### APPEAL SUMMARY

<b>Appeal ID:</b> 21956	<b>Project Address:</b> 1600 SW Salmon St
<b>Hearing Date:</b> 10/2/19	<b>Appellant Name:</b> Tom Jaleski
<b>Case No.:</b> B-016	<b>Appellant Phone:</b> 503.488.5651
<b>Appeal Type:</b> Building	<b>Plans Examiner/Inspector:</b> Jody Orrison
<b>Project Type:</b> commercial	<b>Stories:</b> 6 <b>Occupancy:</b> A-2, A-3, B, E, S-1 / A-5, S-2 <b>Construction Type:</b> I-B, II-B
<b>Building/Business Name:</b> Lincoln High School	<b>Fire Sprinklers:</b> Yes - Main Building; non-sprinklered Grandstands
<b>Appeal Involves:</b> Erection of a new structure	<b>LUR or Permit Application No.:</b>
<b>Plan Submitted Option:</b> pdf [File 1] [File 2]	<b>Proposed use:</b> High School

**Code Section** §1028.1.1.1 Space Under Grandstands and Bleachers

4 LINCOLN HIGH  
SCHOOL  
REPLACEMENT

A128B

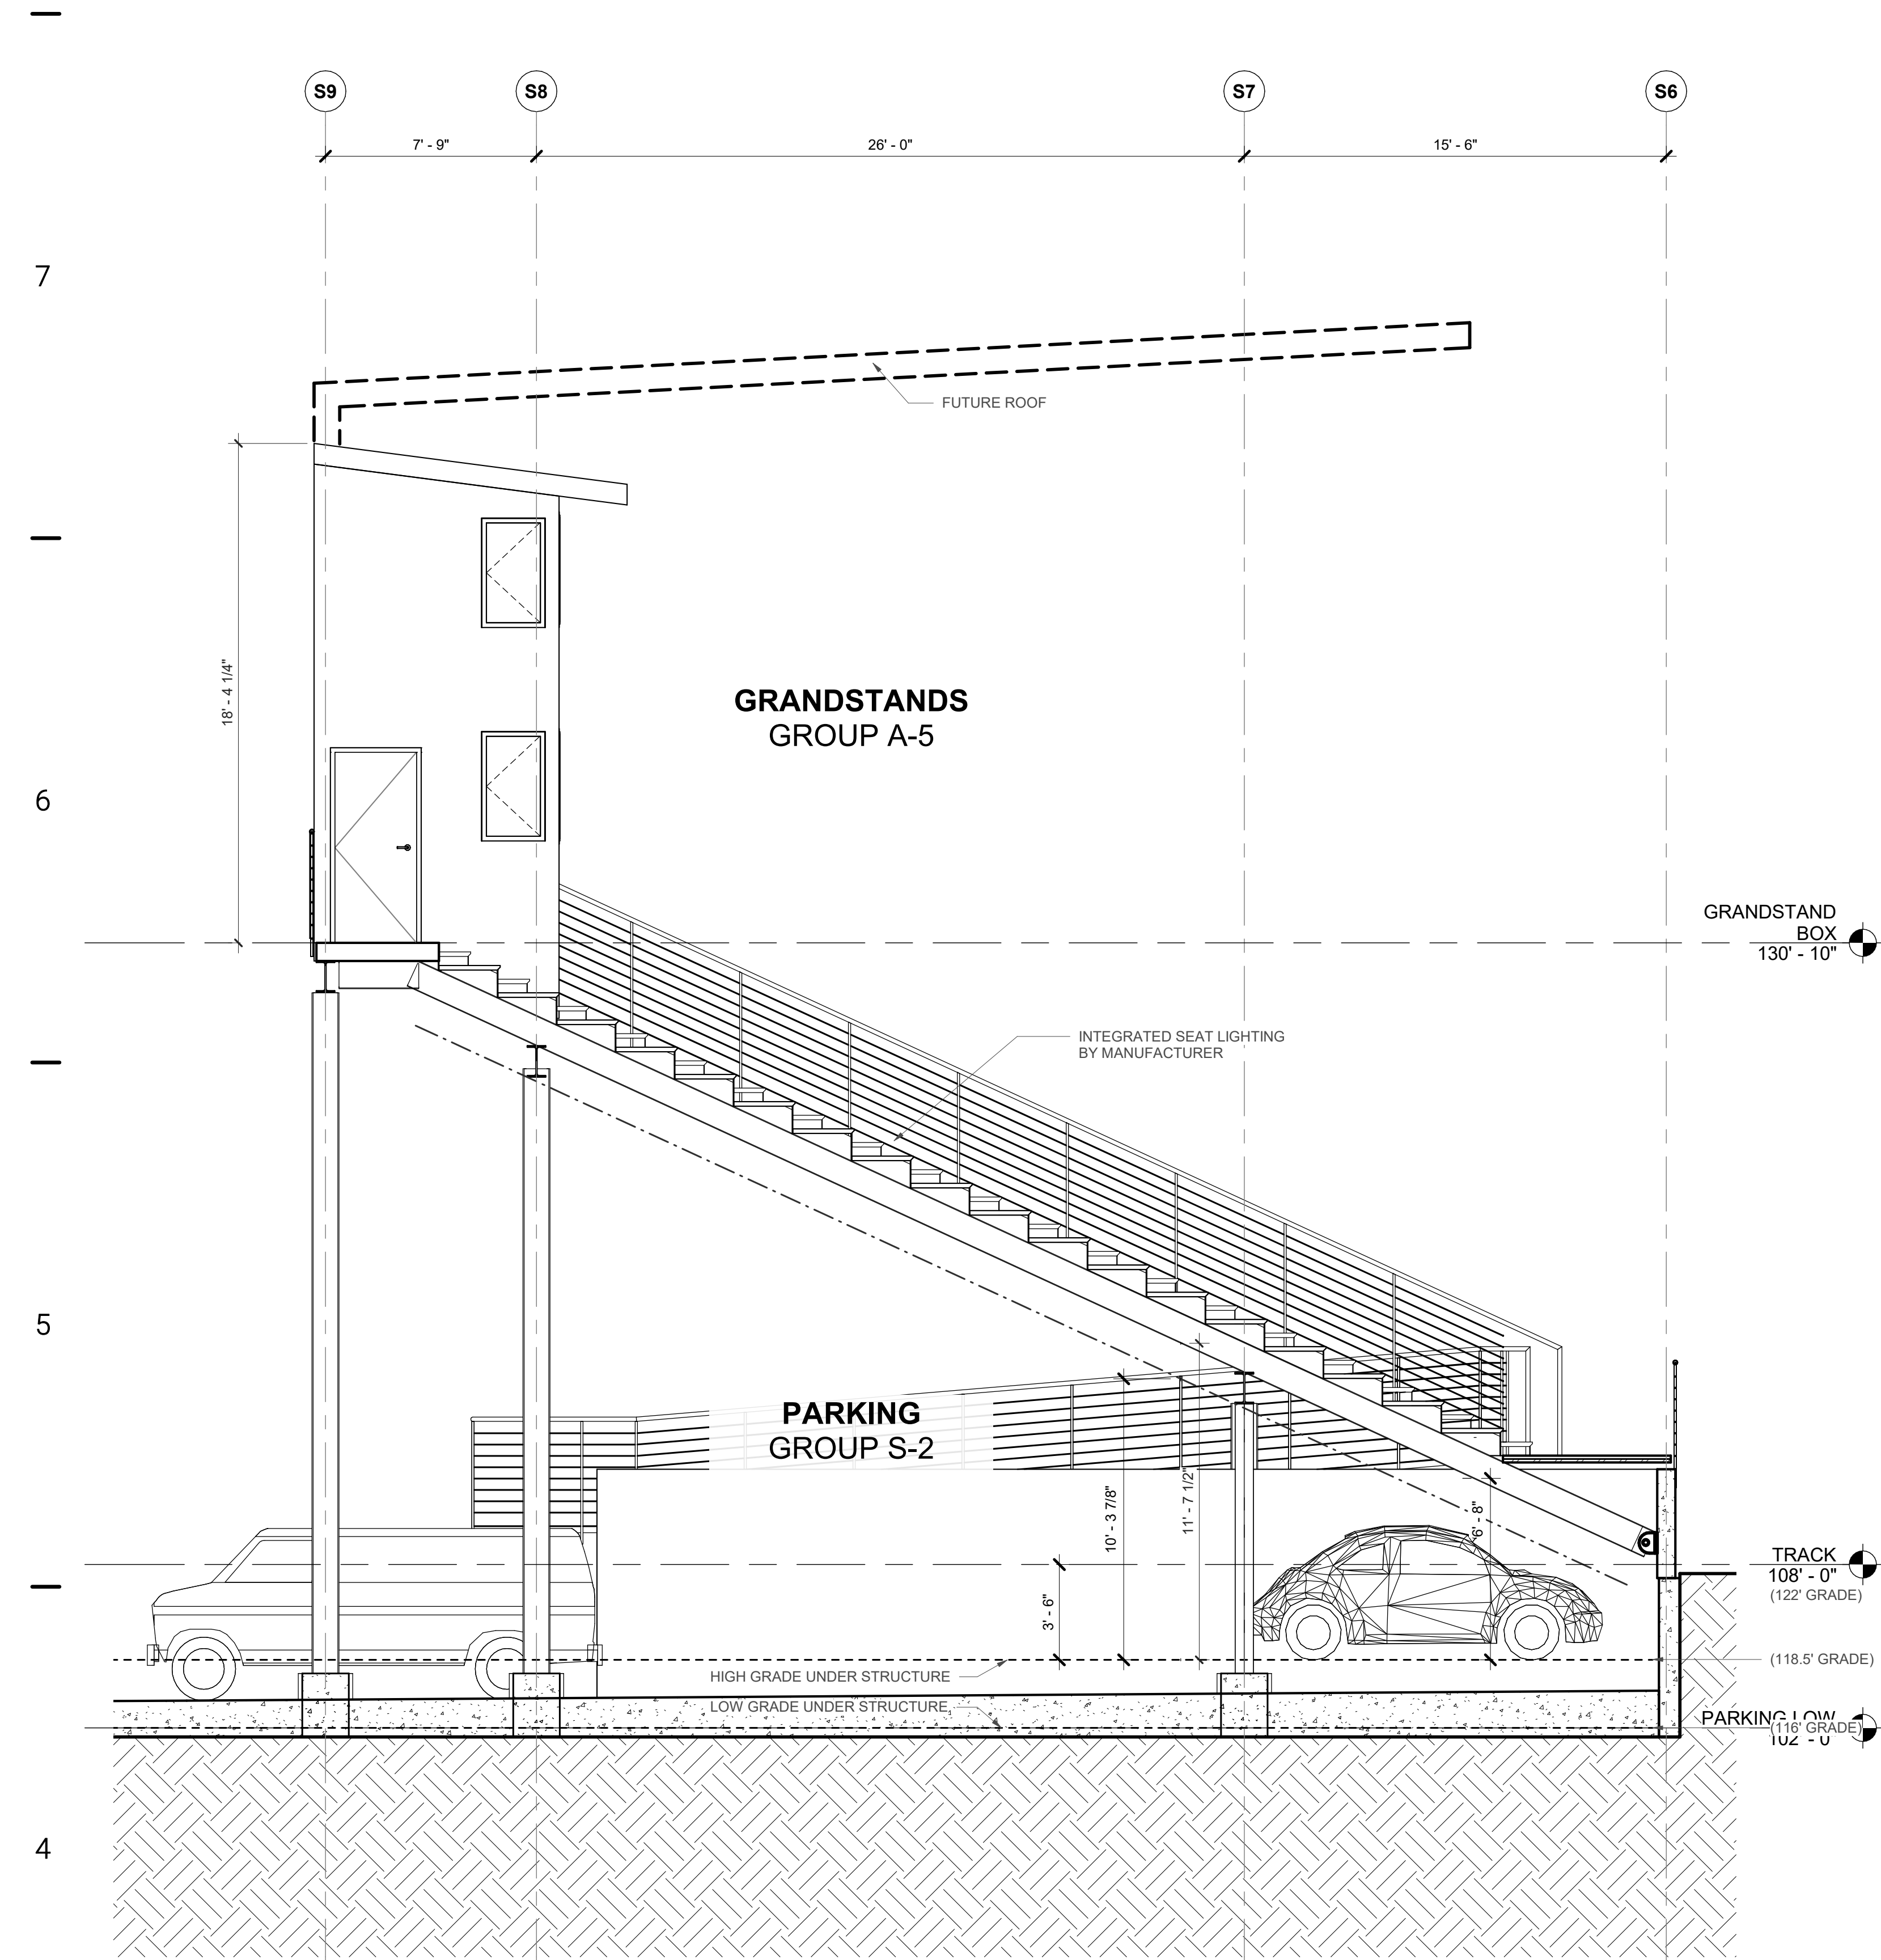
Per §1028.1.1.1, a 1-hour fire barrier separation is required between the seating and the parking. In lieu of a rated separation, the following protocol is proposed:

- The parking area below the grandstands is limited to staff during school hours 7:00AM – 5:00PM.
- The use of the Grandstands is limited to after school hours.
- The parking area underneath the Grandstands will be separated from the remainder of the parking lot during after-school events; this separation will include a chain to be linked between permanent columns that support the Grandstands.
- At the Grandstands, the District will install signs stating, "NO PARKING DURING ATHLETIC EVENTS. VEHICLES WILL BE TOWED AT OWNERS EXPENSE."

The chains will provide a physical separation at the parking underneath the Grandstands during after-school events and is proposed as a new addition to increase the protection of the assembly occupants. This separation ensures that those parking stalls will not be used and that vehicles will not drive underneath the Grandstands during an event

Therefore, in lieu of separating the bleacher seating from the parking below with 1-hour fire-resistance-rated construction, protocol would prohibit the use of the parking stalls below the Grandstands when occupied for after-school assembly events.

**2. Parking located beneath grandstand: Granted provided the parking area below the grandstands is limited to teachers during school hours 7:00AM – 5:00PM and provided the use of the grandstands is limited to after school hours and provided the District installs signs stating "NO PARKING DURING ATHLETIC EVENTS. VEHICLES WILL BE TOWED AT OWNERS EXPENSE" and provided a sign is installed at the entry gates stating "PARKING LOT TO BE FREE OF VEHICLES AND LOCKED DURING ATHLETIC EVENTS".**
